OICA contribution to PMP

28 Sep 2023

Technical Details to ANNEX-C and GTR-24

Usage of rotational Wheel Velocity

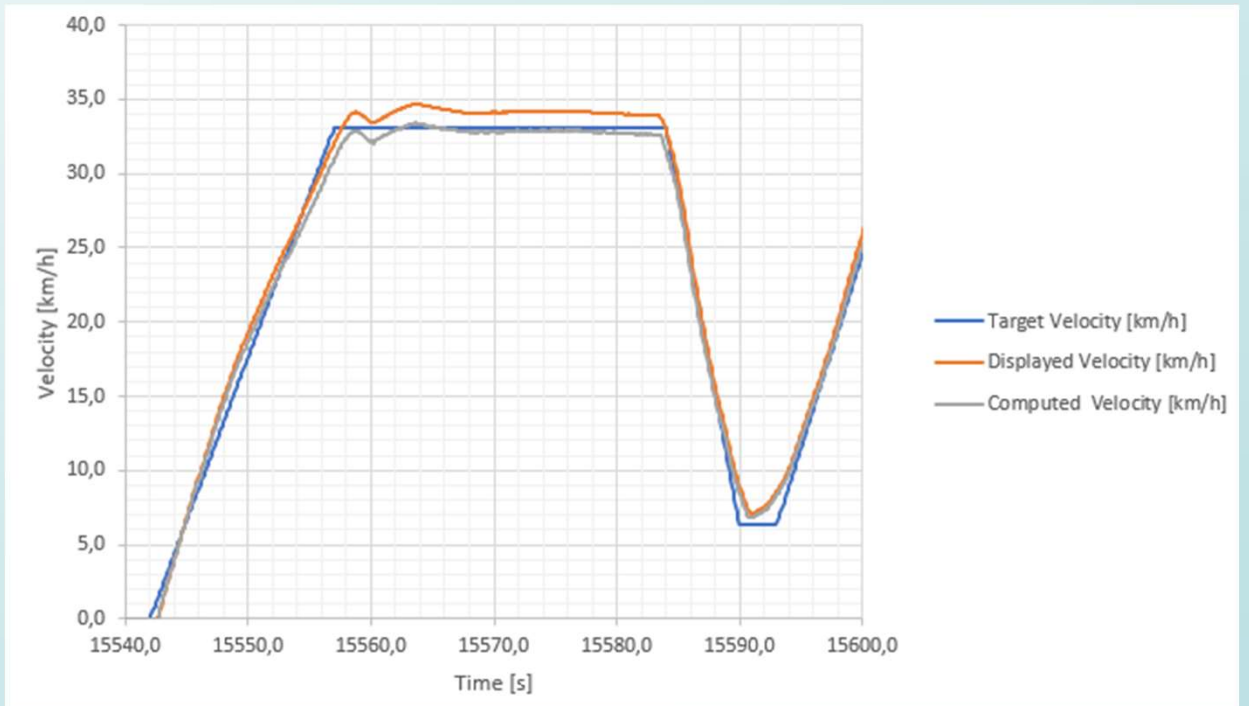
Currently most formulas using the translatory vehicle velocity. This does not consider an eventually difference at each wheel and introduces additional computations. Usually the sensors on dynos or cars measure the rotational velocity.

- Multiple forward/backward conversion of velocity with r_{dyn}
- Not exact values per wheel/axle and potentially incorrect values if **translational** CAN-Bus Signals are used (offset)
- But **rotational** CAN-Bus Signals are without offset so they might be used

- Usually all velocities are computed from the rotational velocity sensors ($v = \omega \cdot r$)
- Most of the formulas are using torque signals
- → It would be more meaningful to stick to the rotational velocity directly
- → this is also defined per wheel and not just for the whole vehicle

Modify formulas to use measured rotational wheel velocity.

Brake Events in WLTP Exhaust

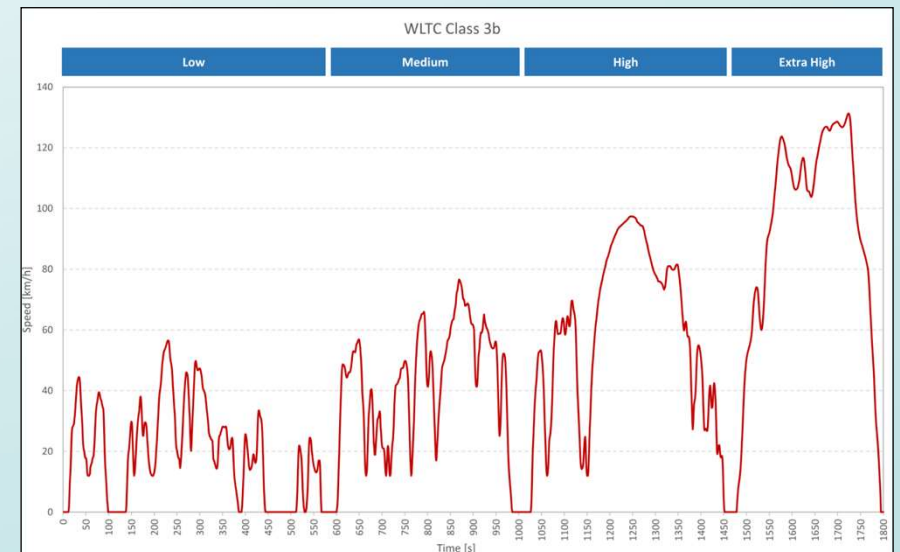
How are the brake events or phases of deceleration defined if the WLTP Exhaust should be used for the computation of the friction share factor?

- Unclear integration intervals
- Different results in each house

- The WLTP Exhaust has not the same clear „braking phases“ as the WLTP Brake
- Rather very „smooth“ deceleration
- Also use following condition for integration:

It is necessary to define the brake events.

Consideration of Pressure

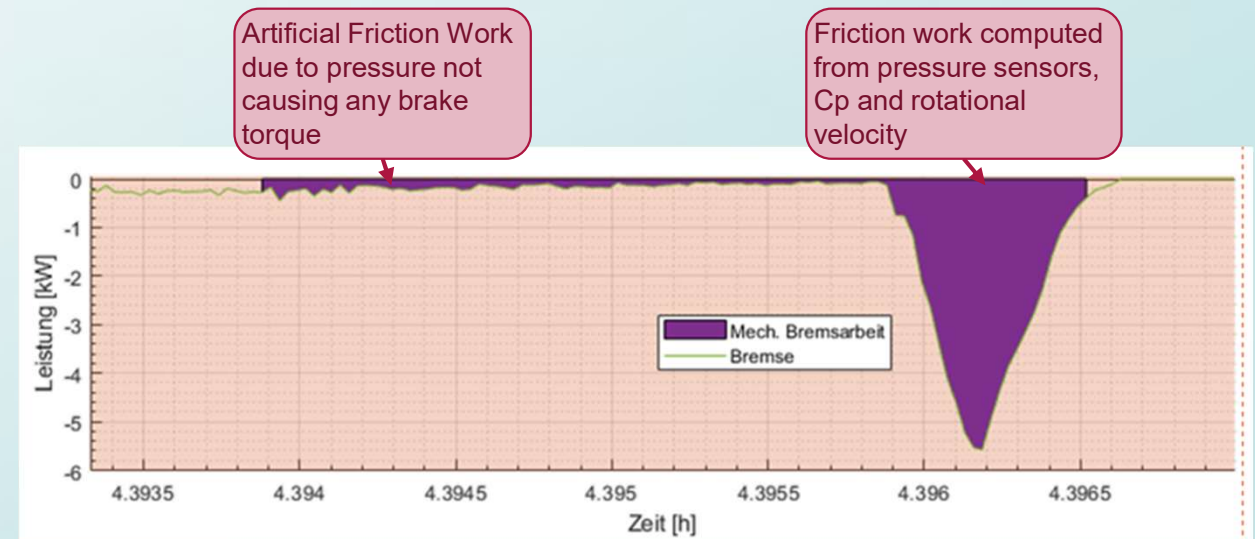
Currently no pressure threshold for the computation of torque (friction power → friction work) is given. Hence mechanical threshold and sensor noise might introduces artificial friction work.

- As stated in section 3.1.19 of the GTR a “Threshold Pressure” exists which is the minimum hydraulic pressure to overcome the internal friction and seal forces to move the brake calliper piston or drum wheel cylinder and onset brake torque output.
- Hence there will be no brake torque if the brake pressure is below this threshold. This must be considered for the computation of the friction brake power:

The pressure threshold for the signals as stated in table 8.1 of GTR24 main text shall be applied.

Consideration of Threshold for Torque

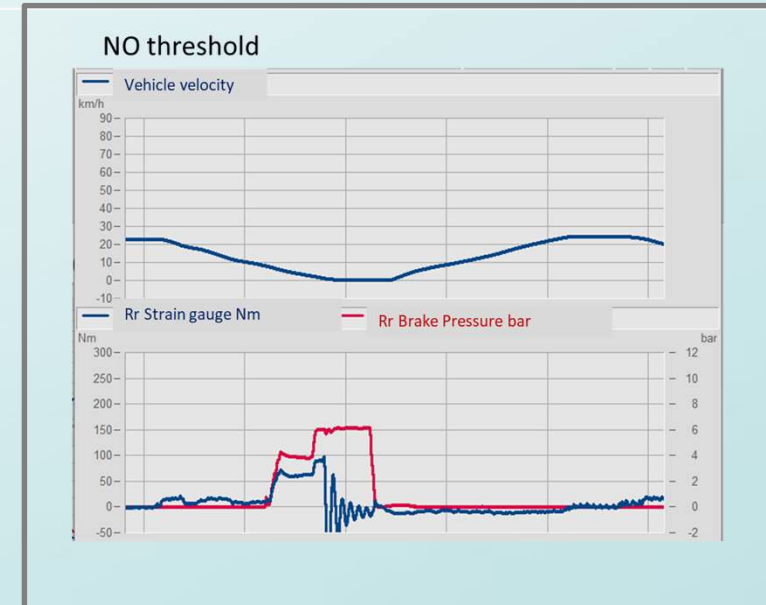
Currently two methods to measure torque are described, i.e. Piezo Sensor and Strain Gauge method. How to deal with zero-offset and drift of zero line?

There could be a false zero torque reading, which would be integrated during brake events.

- Two methods have different accuracy and stability
- Strain gauge method requires weakening of caliper/bracket- which require expert knowledge
- Strain gauge method appears to have higher deviation- suitability?
- Base line correction and procedure is currently unclear
- Need a clear description, if and how base line torque may be corrected
- High accuracy is particularly needed for highly recuperating vehicles

- Two torque methods have very different sensitivity. Accuracy and stability is currently unclear and needs to be further elaborated
- A threshold torque might be needed

Definition of Brake Event Start/End Time and Intervals

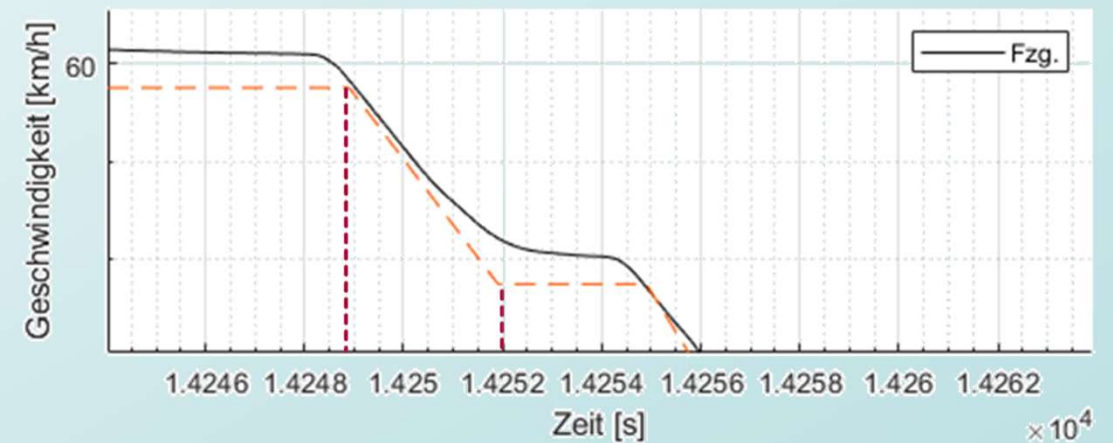
Which intervals are relevant for the integration and analysis of the brake stop event?

- Unclear intervals of integration or analysis in different houses
- Different results and inconsistency of data

- Setpoint means the reference/target value of the cycle?
- Instead of using start and end time of each brake event (multiple integral ranges) one could consider the friction power only where the acceleration of the **reference/target** is below zero?:

Add the above mentioned formula to the GTR.

Numeric Implementation of Integration

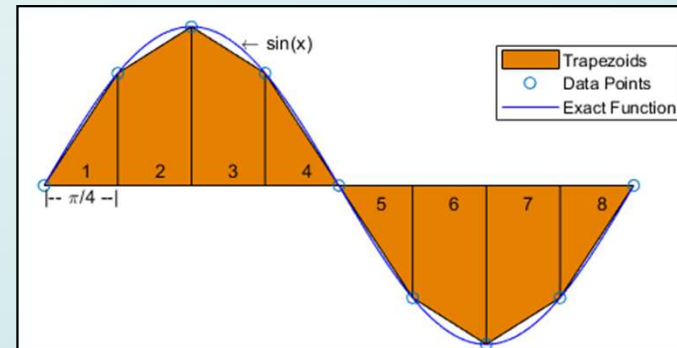
How should the integration be done?

- Currently it is not defined how the integral should be computed

- It is suggested to use the most easy one, the trapezoidal method:

The exact numerical integration of the measured values shall be defined precisely.

Identification of family parameters

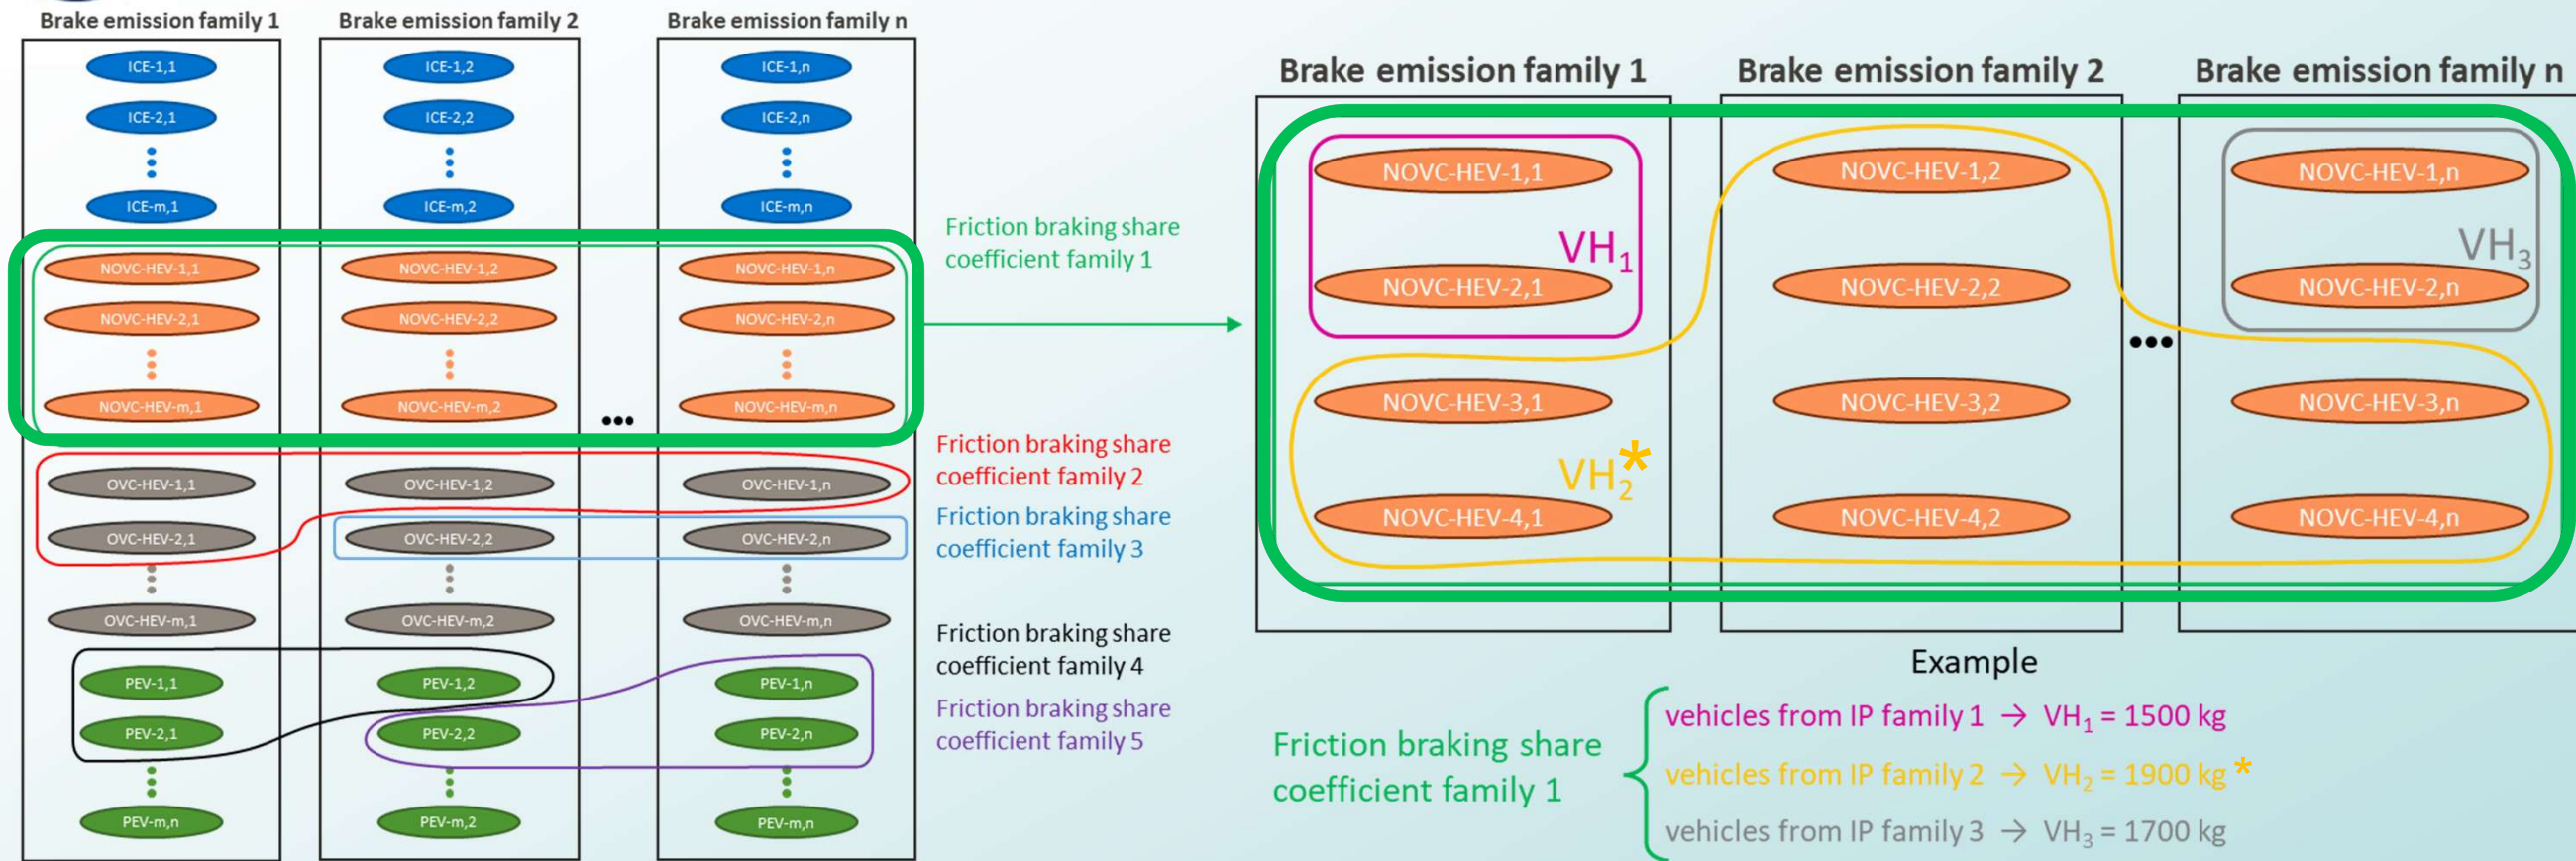
Only electrified vehicles (OVC-HEVs, NOVC-HEVs, PEVs) that are identical with respect to the following powertrain characteristics may be part of the same friction braking share coefficient family:

- Type and number of electric machines
- Traction REESS nominal power
- Type of electric energy converter between the electric machine and traction REESS
- Number of powered axles
- Brake control system (Regen. strategy needs to be the same). To be further detailed

A friction braking share coefficient family is a group of several IP families

The Vehicle High with the highest test mass of a friction braking share coefficient family shall be selected for testing (VH_2^* in the above example).

In case of same vehicle mass the one with the highest battery capacity shall be selected.

Need for axle-specific friction braking share coefficients

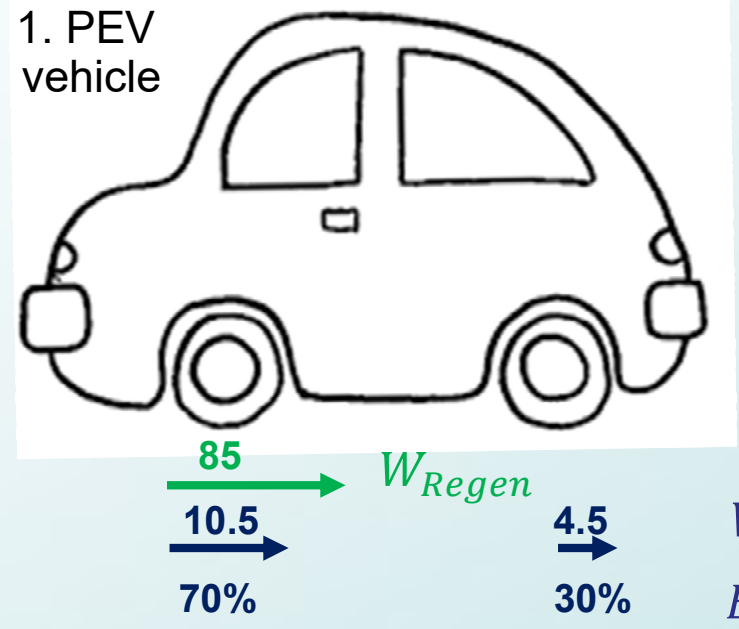
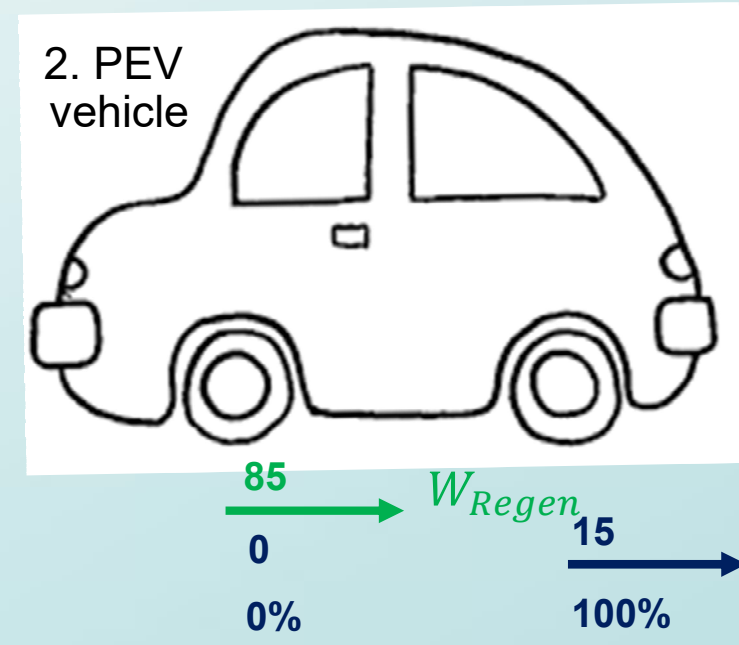
Electrified vehicle **recuperating only on the front axle** **with fixed brake force distribution**

The axle-specific coefficients are equal

Electrified vehicle **recuperating only on the front axle** **with axle wise brake pressure control**

The axle-specific coefficients are not equal

Axle-specific friction braking share coefficients are needed for those vehicles whose brake pressure control for each axle is independent of one another.

Definition of axle-specific friction braking share coefficients

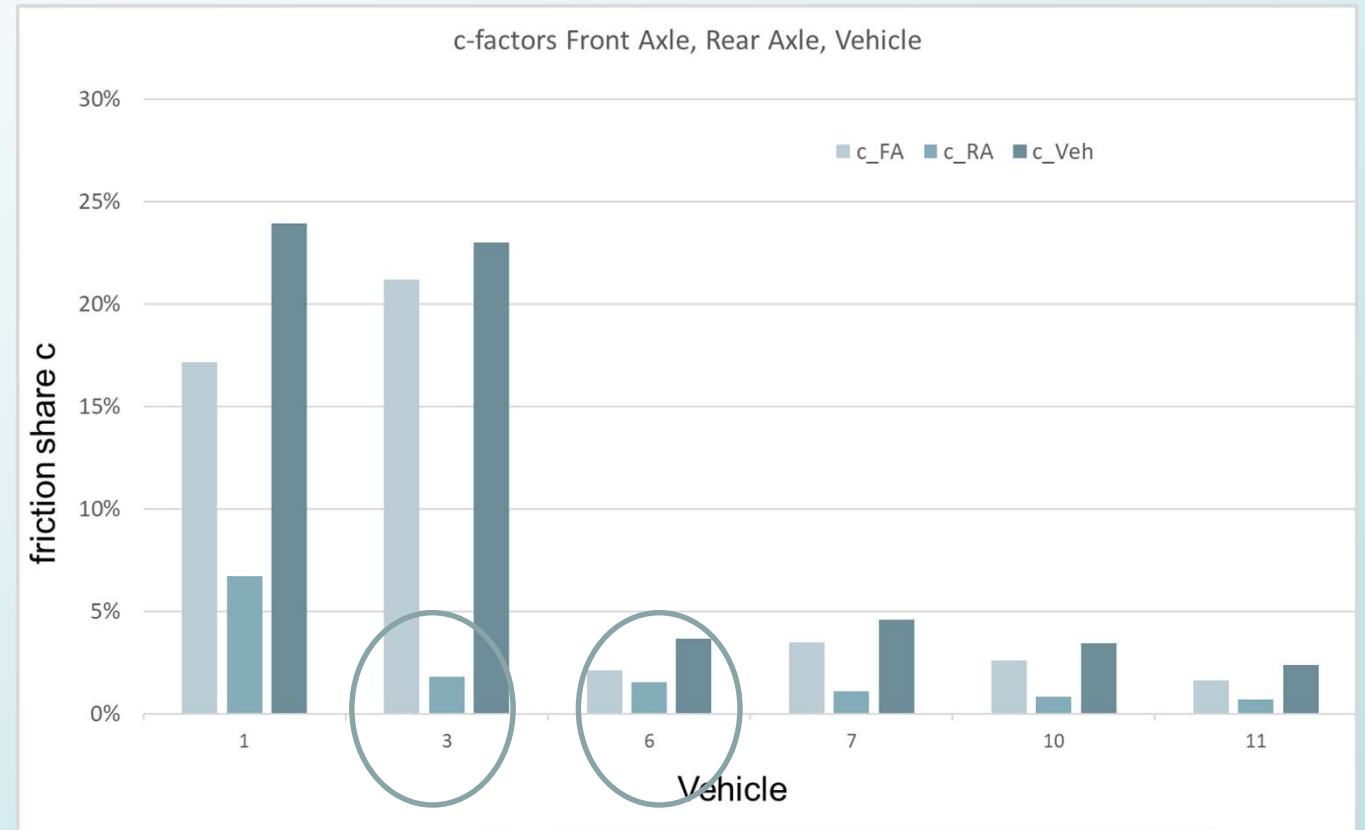
$$c_{FA} = \frac{W_{brake,FA}}{W_{ref}} \quad \longrightarrow \quad c = c_{FA} + c_{RA}$$

By this definition the vehicle friction share coefficient (c) is the sum of front axle (c_{FA}) and rear axle (c_{RA}) friction braking coefficient
